PK22 Dimensions

New design compared to original design

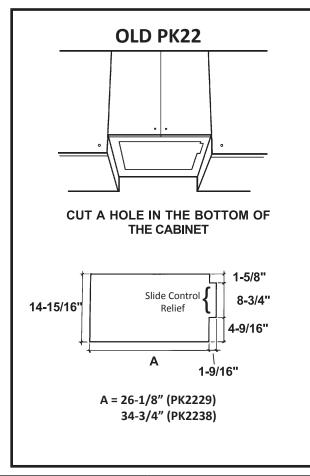
The **primary cut-out dimensions** are within 1/16" for depth and width (excluding the control cut-out on the old models). A new model has been introduced in 45" widths.

While the new model will fit into the cut-out opening of the old PK22, the cut-out may not be covered fully by the new PK22 face frame due to the relief for the slide control in the old model. Please plan accordingly to cover this area so it is not exposed.
